**FIRST CERCLA FIVE-YEAR REVIEW FOR SITE SS001  
AND  
SECOND CERCLA FIVE-YEAR REVIEW FOR SITE SS003  
AT THE NORTH RIVER RADIO RELAY STATION  
UNALAKLEET, ALASKA**

**Final  
December 2021**

**APPENDIX E**  
**RESPONSE TO COMMENTS**

**SITE MAP**

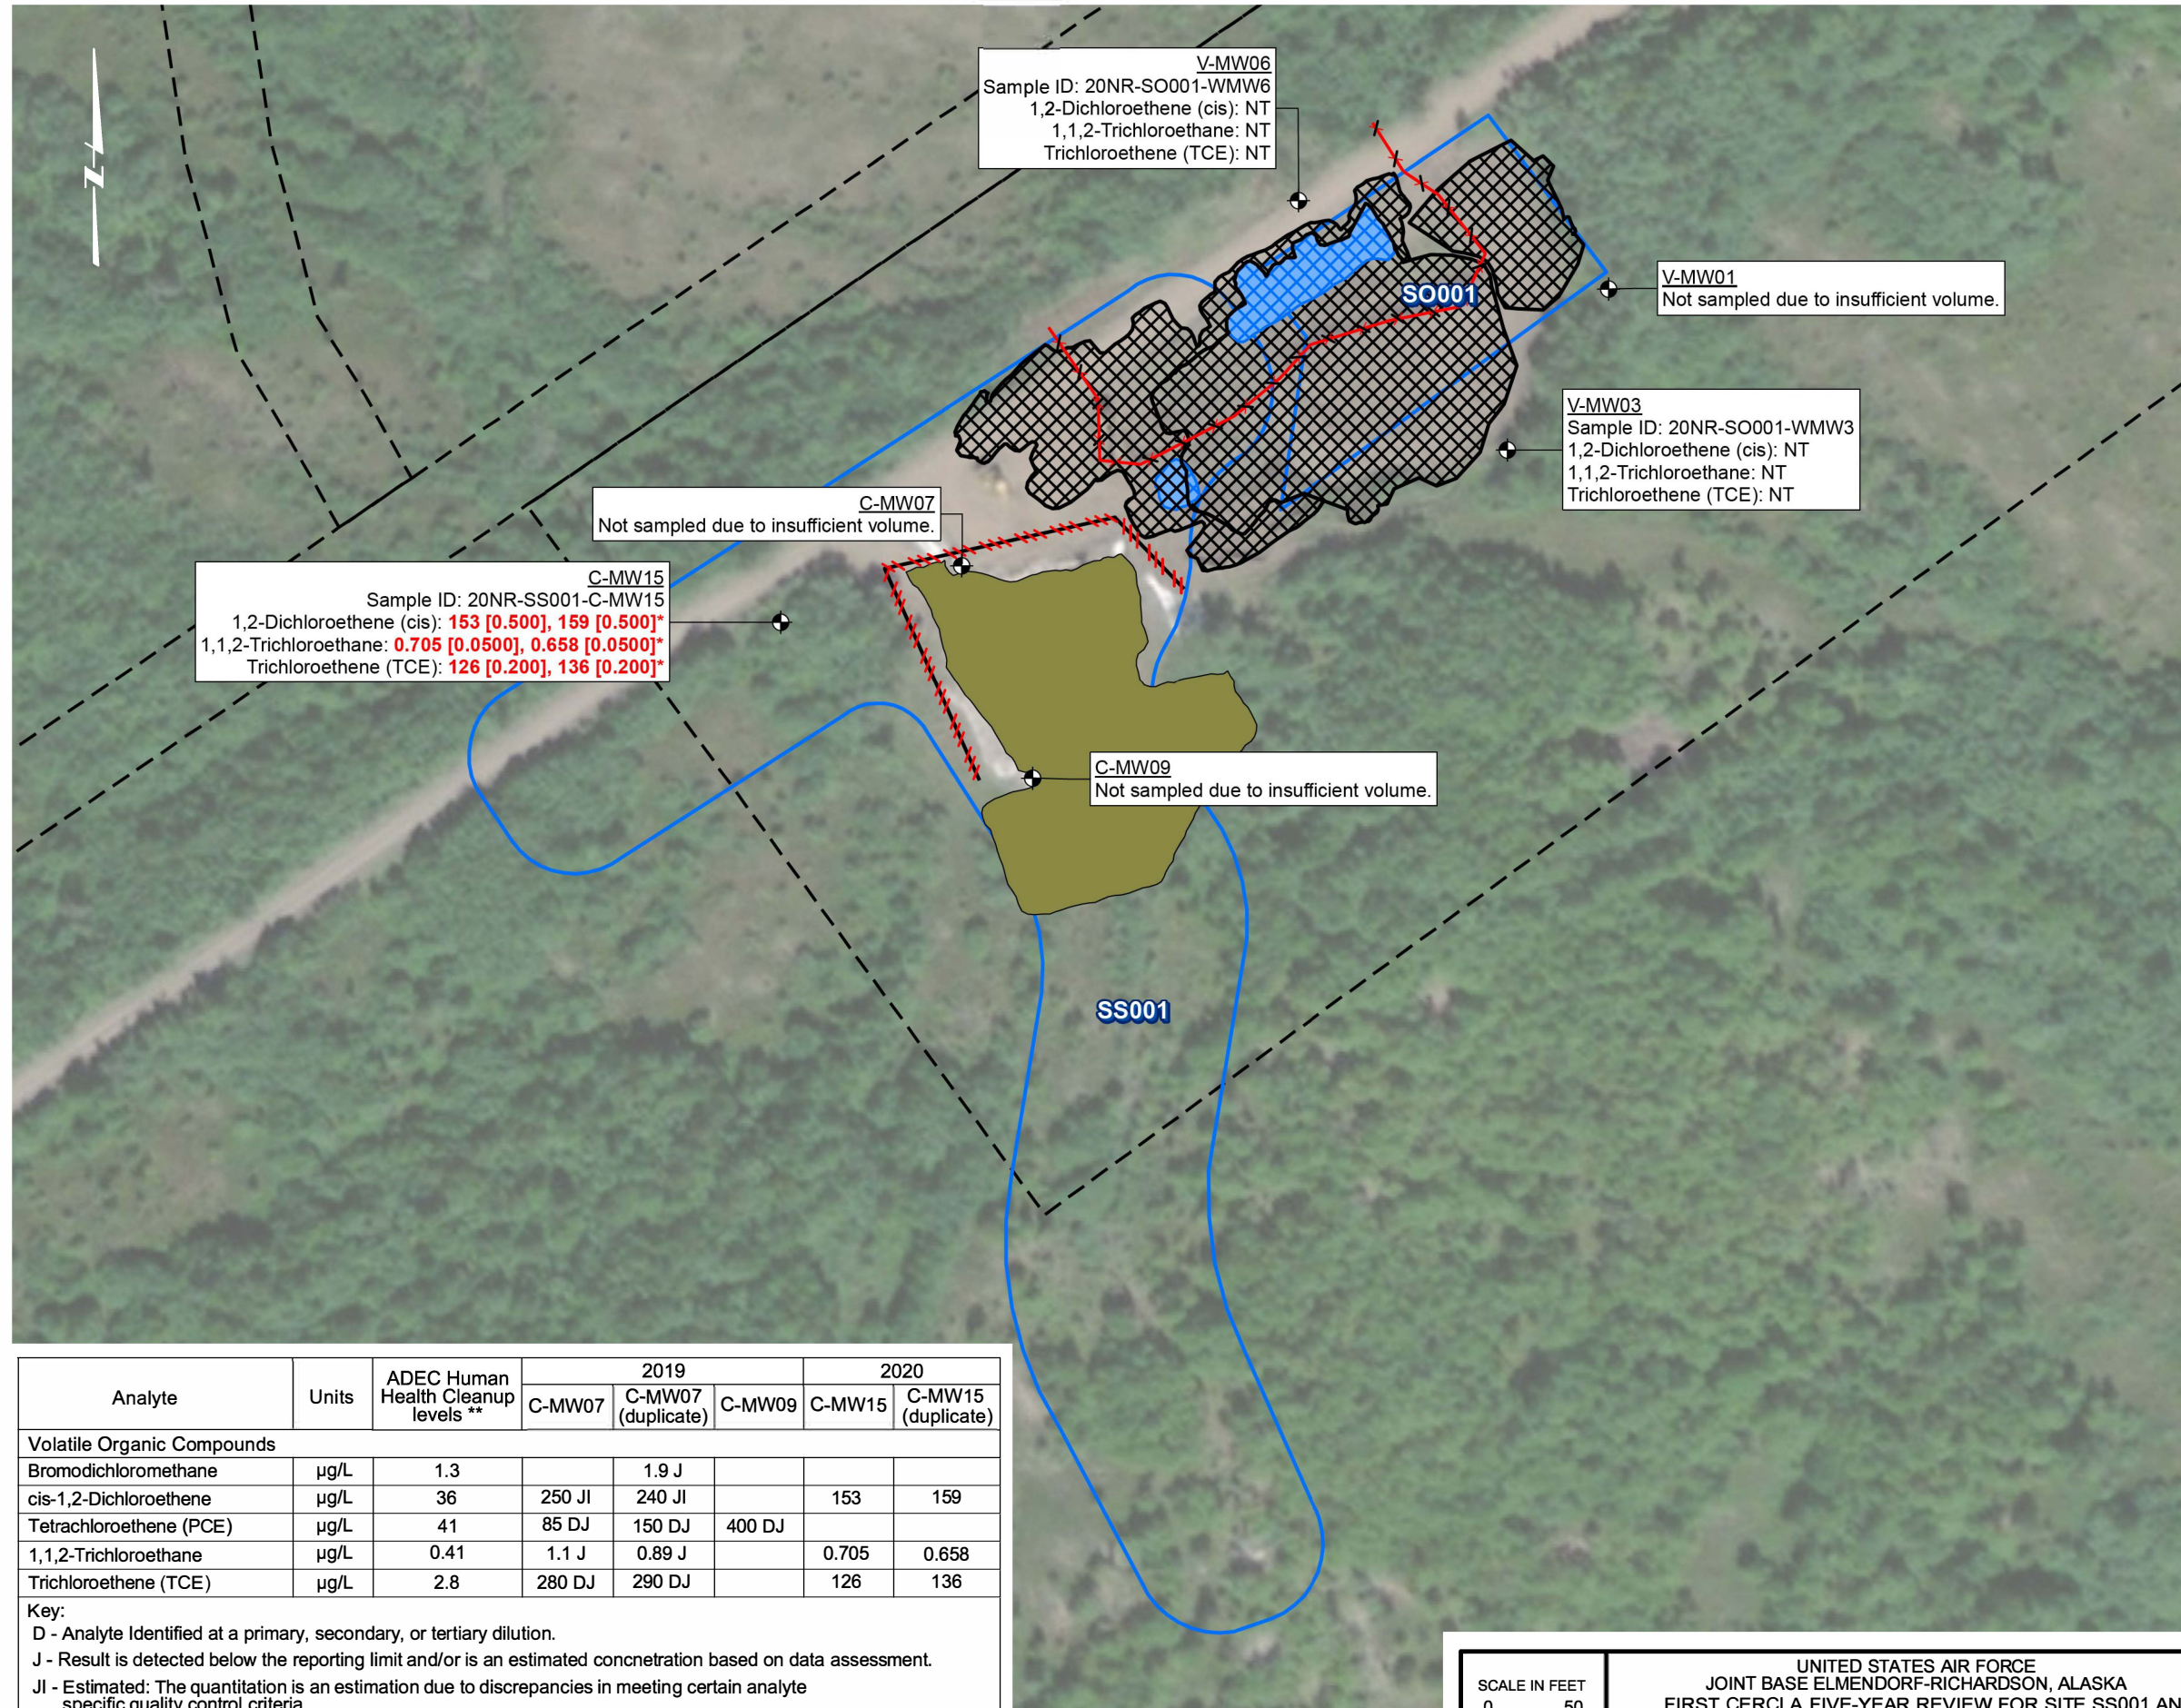
10.	25	Issue Category: Institutional Controls	<p>DEC believes the LUC boundaries not being in the LUC Management Plan, the NAUL and covenant not being recorded for the properties, and the lack of signage all affect current protectiveness. Revise the text.</p>	<p>Noted. The LUC Management Plan is currently being updated with an anticipated mid 2022 publication date, which will incorporate the new site boundary</p>

12.	Figure 2		<p>Since the COPC were discovered by the Monitoring Wells they should be included in the figure for reference.</p>	<p><b>Agree:</b> Figure 3 had been added to incorporate the 2019 and 2020 groundwater monitoring data.</p> <p><b>DEC Accepts 11/02/2021</b></p>
End of comments.

Comment No.	Page	Section	Comment / Recommendation	Response
				<p>for SS001 as shown in Figure 2 Site Map of this FYR. The USAF is managing the site per this figure regardless of the publication date of the LUC Management Plan update.</p> <p><b>DEC Accepts 11/02/2021</b></p>
